**Comment Form for 1<sup>st</sup> Draft of Standard PRC-023-1 — Transmission Relay Loadability**

## Comments on NERC Line Loadability Standard PRC-023 Reference

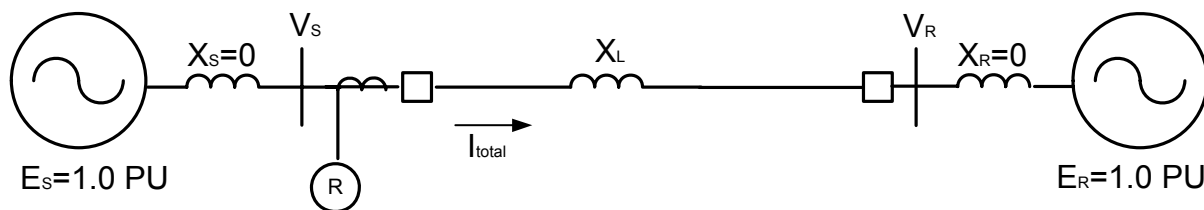
Most WECC members are well aware of the problem of setting zone 2 or zone 3 distance relays on long transmission lines with enough reach to adequately protect the line without violating NERC recommendation 8A. The problem arises because the thermal current limit of a line is independent of the lines length and does not change for a given conductor size no matter how long it is. The impedance of the line, however, increases with the lines length. As the line length and impedance increases, the reach of the distance relays that protect the line must also increase to provide adequate protection, until at some point the relay setting would operate for the maximum thermal current. This creates the dilemma of how to protect such a long line without limiting its load carrying ability.

On the other hand, as the line length and impedance increases, the ability to transfer power across the line diminishes until a point is reached where the maximum possible power transfer is less than the rated thermal power transfer limit. Using this diminished power transfer capability instead of the thermal limit as the basis of setting the reach of the distance relays should allow for a longer relay reach that will hopefully provide adequate protection for the line.

Requirements R1.3.1 and R1.3.2 of NERC Standard PRC-023-1, and as detailed in the *PRC-023 Reference*, attempt to allow the use of the maximum power transfer capability of a line to justify the use of relay settings that will operate at loads less than the line's thermal rating. While this approach has merit, I have the following concerns:

## 2) R1.3.2 Offers Little Help Over R1.3.1

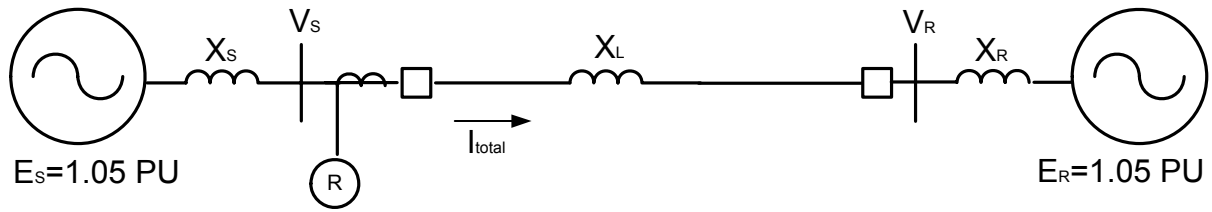
R1.3.2 uses the source impedances of the system to obtain a reduced maximum theoretical power flow at the power angle,  $\delta$ , of  $90^\circ$ , and therefore a longer allowable relay reach than obtained by R1.3.1

As in R1.3.1, R1.3.2 applies the relay reach at a power factor angle of  $30^\circ$  instead of the correct angle of  $45^\circ$ . Using  $45^\circ$  results in even less allowable relay reach.

### 3) Another Approach

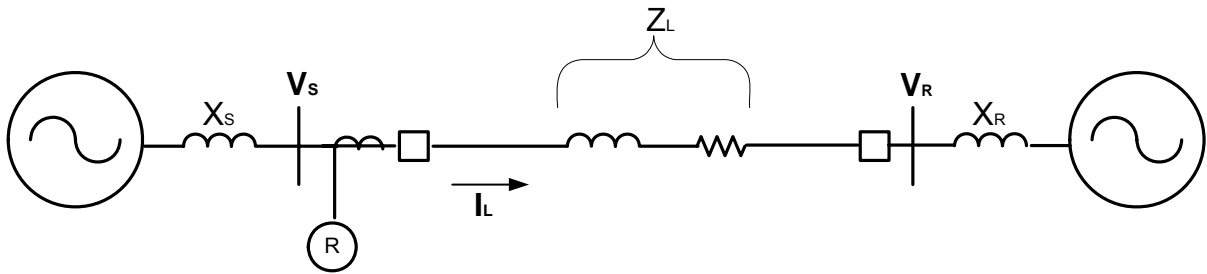
From the above diagram where  $V_s$  is the phase-to-ground voltage at the sending end, and  $V_R$  is the phase-to-ground voltage at the receiving end:
